APP/17/01071: Northney Farm Tea Room

We wish to comment on the proposed expansion of Northney Farm Tea Room. We are the owners of "Meadowsweet", the 16th-century Grade 2 Listed Building which is adjacent to the Tea Room. Our barn is attached to the barn of the tea-room complex, and our garden is close to its patio.

PROPOSED PLAN

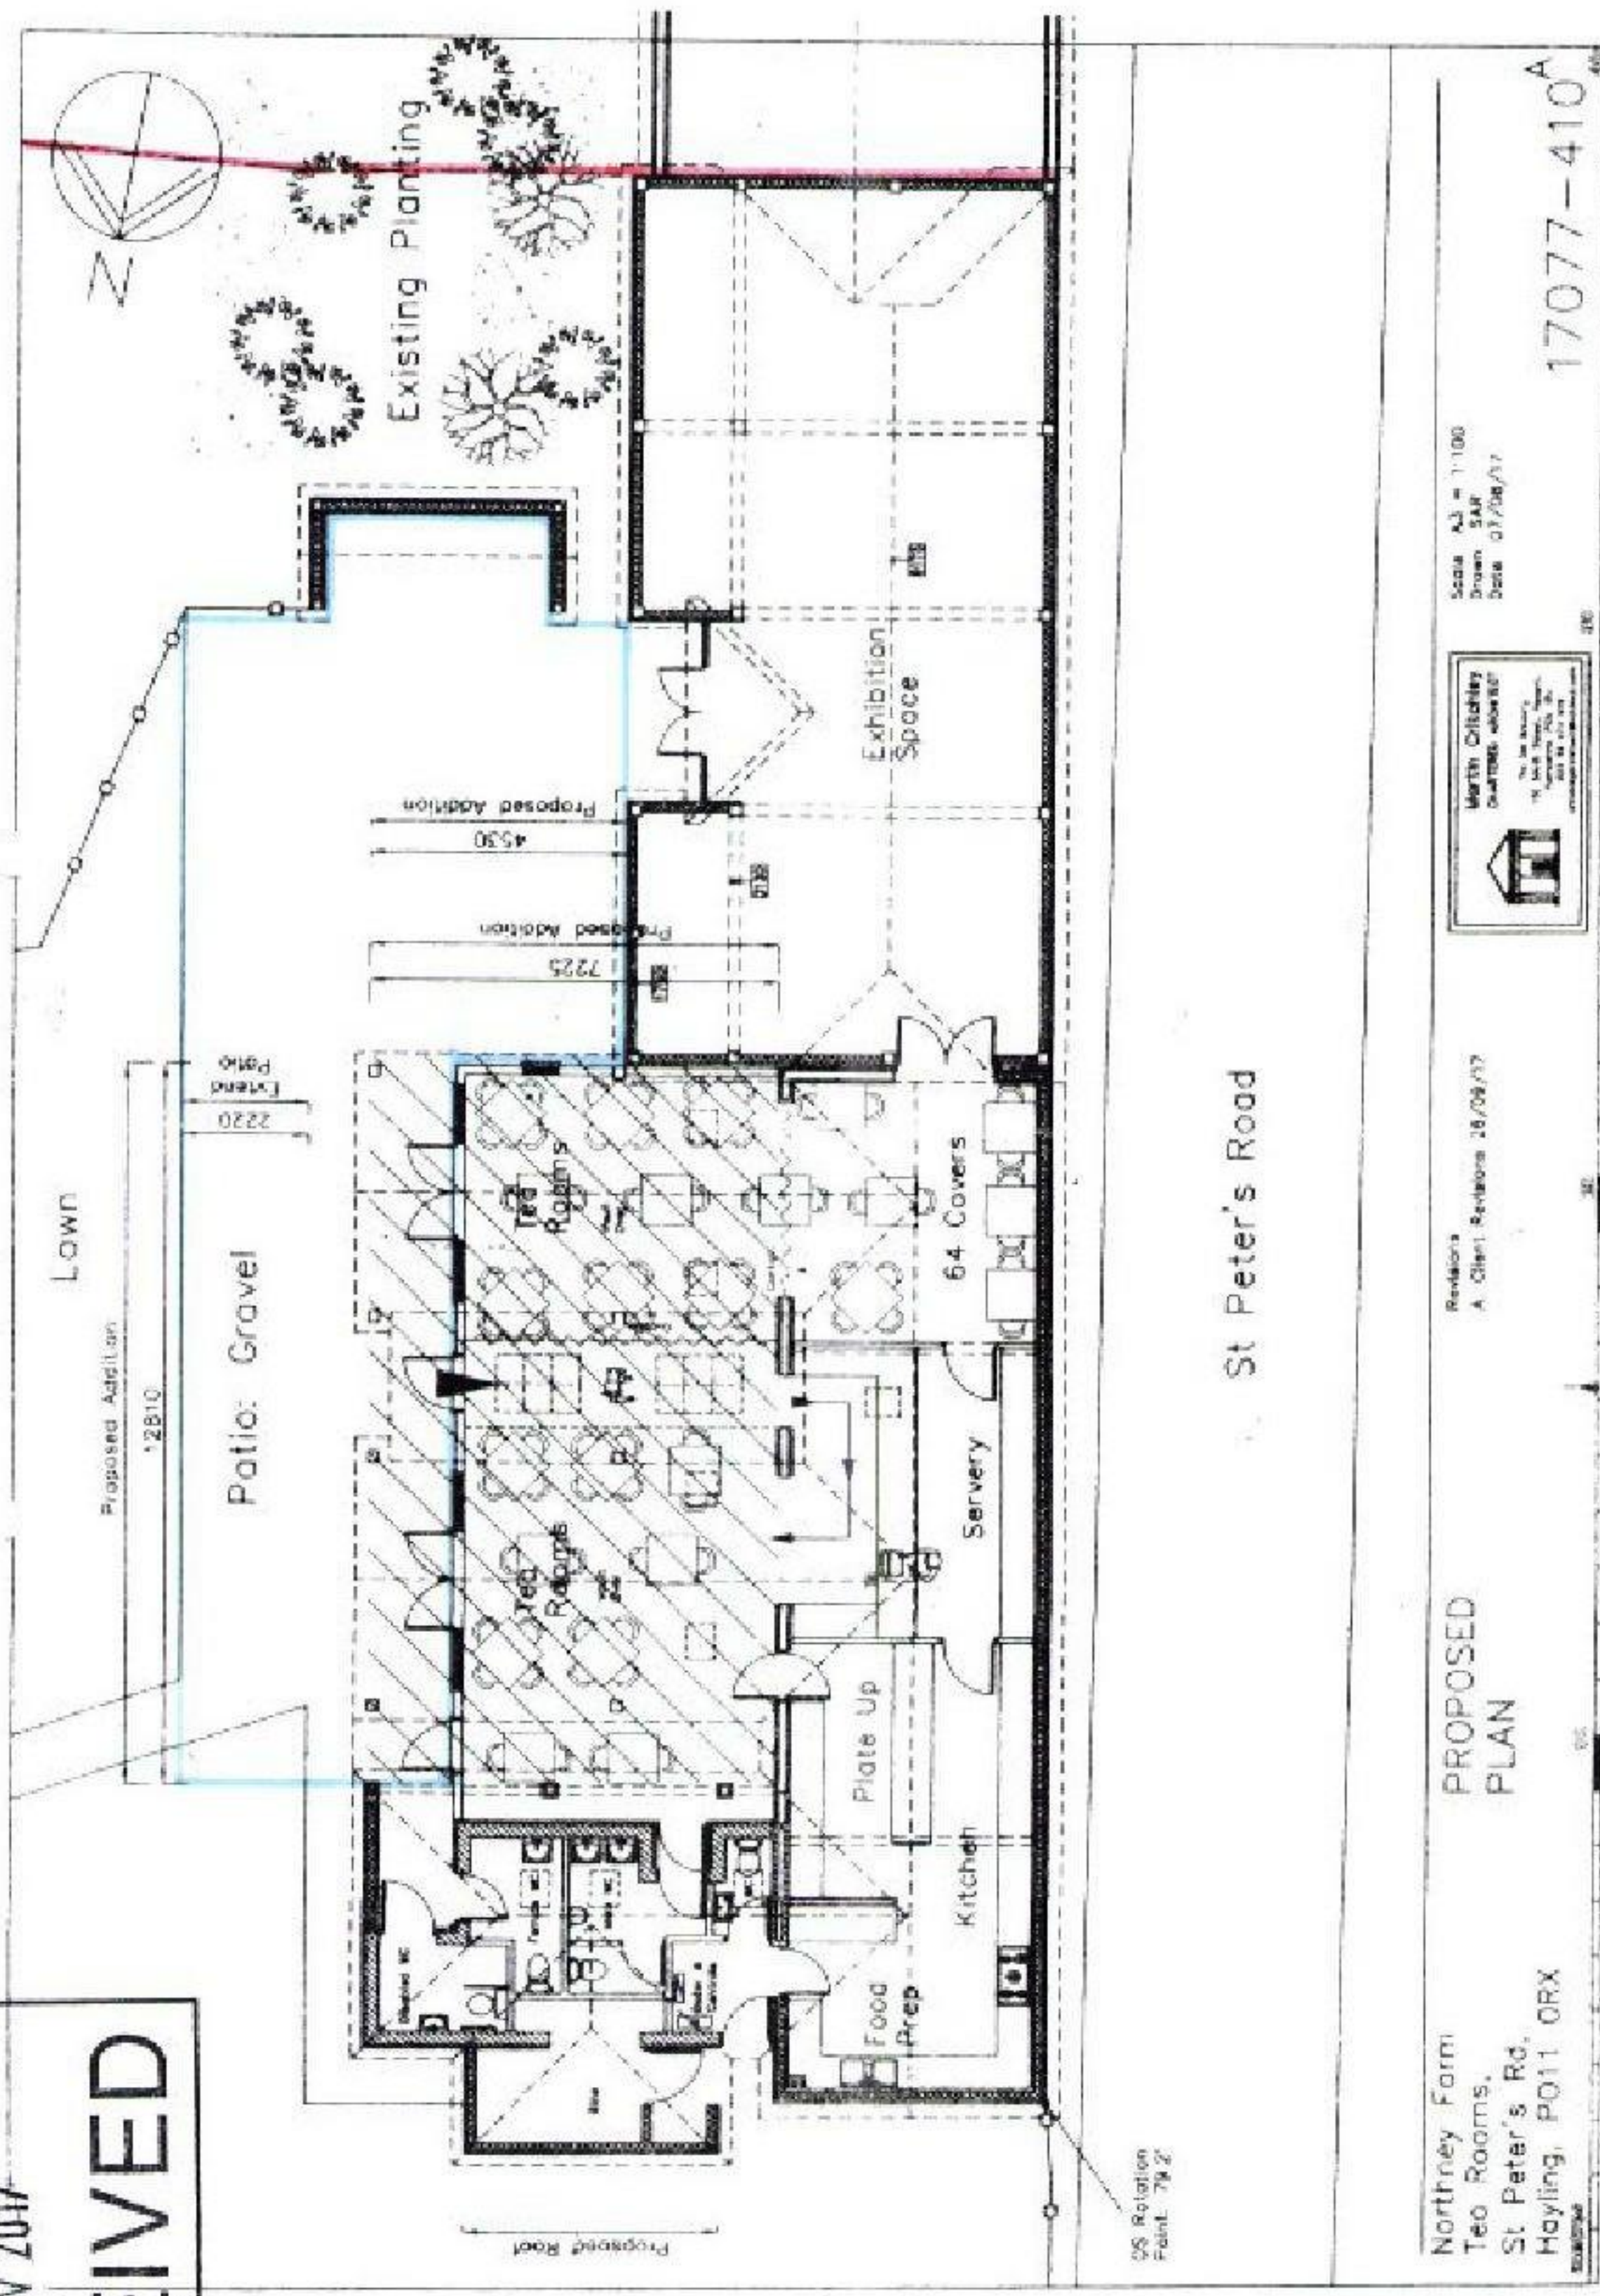
The proposal calls for a new but smaller terrace area of 124 m², just over 50% of which would be adjoining the barn. In terms of present visitor numbers, we must therefore expect $50\% \div 32\% = 160\%$ more guests who will use the patio next to our garden; see page 5 below. Including the planned upgrade from 32 to 70 covers inside the tearoom, barn patio use would rise by 350%, clearly not a nice prospect.

Being already a very successful commercial project, there is little doubt that visitor numbers to the tearoom would rise significantly following the proposed expansion. Also, when people are closer together they will raise their voices to be heard, resulting in a disproportionate increase in sound levels.
